## Addendum #2

<b>PROJECT:</b>	<b>ADDENDUM NO.</b>	002
<b>IVH Sheeler – Loftus Remodel</b>		
<b>Iowa Veterans Home</b>	<b>DATE ISSUED:</b>	11/27/2017
<b>1301 Summit Street, Marshalltown, IA 50158</b>	<b>BIDS DUE:</b>	12/06/2017 (Revised Date)
<b>DAS # 8950.00</b>

**TSP PROJECT NUMBER: 06-170221.00**

SIGN TYPE 1  
1/4"=1"

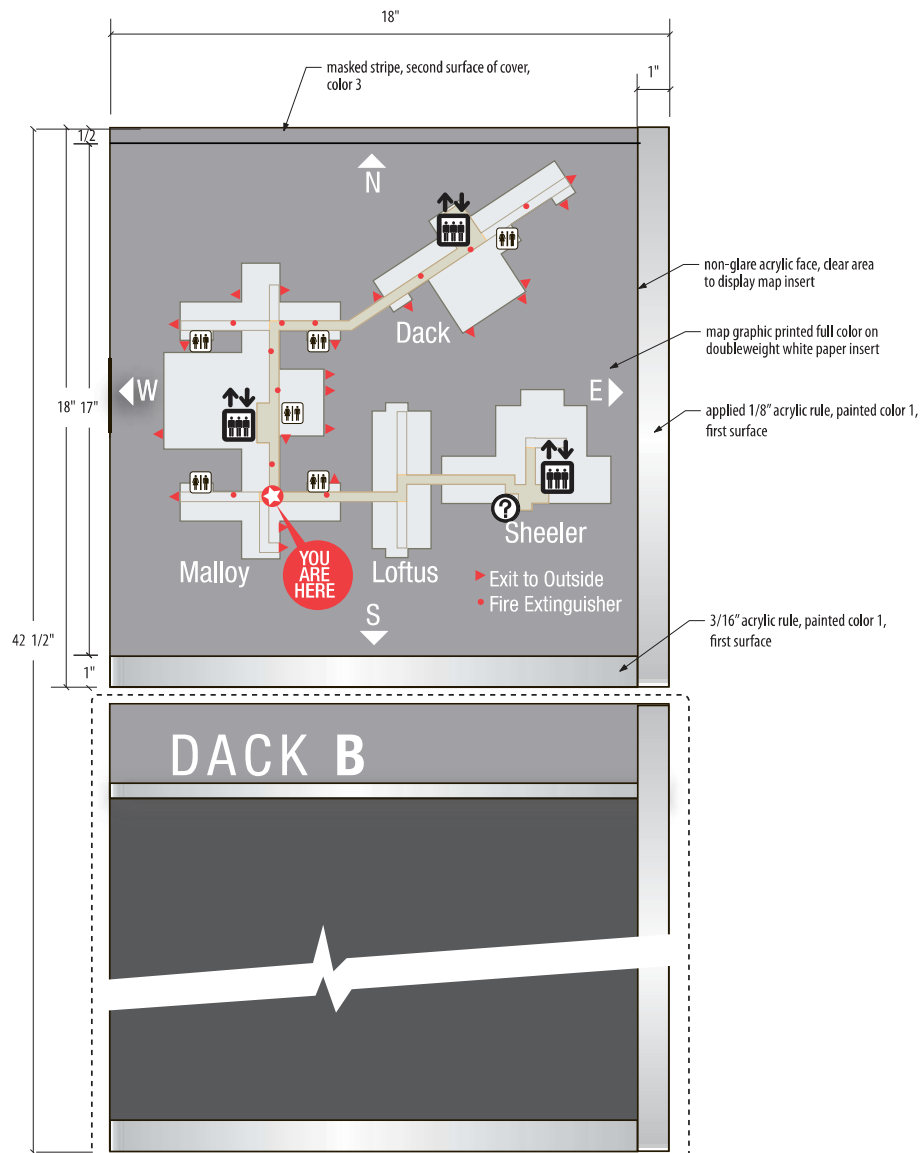
- A. Interior Plaque Signs
  - 1. "Sign Type 1" : Qty 1
    - a. Reference attached drawing
    - b. Double sign 18" x 42 1/2" (1 @ 18" x 18", 1 @ 18" x 24")
    - c. "LOFTUS 1"
  - 2. "Sign Type 4" : Qty 1
    - a. Reference attached drawing
    - b. 18" x 24"
    - c. "LOFTUS 1"
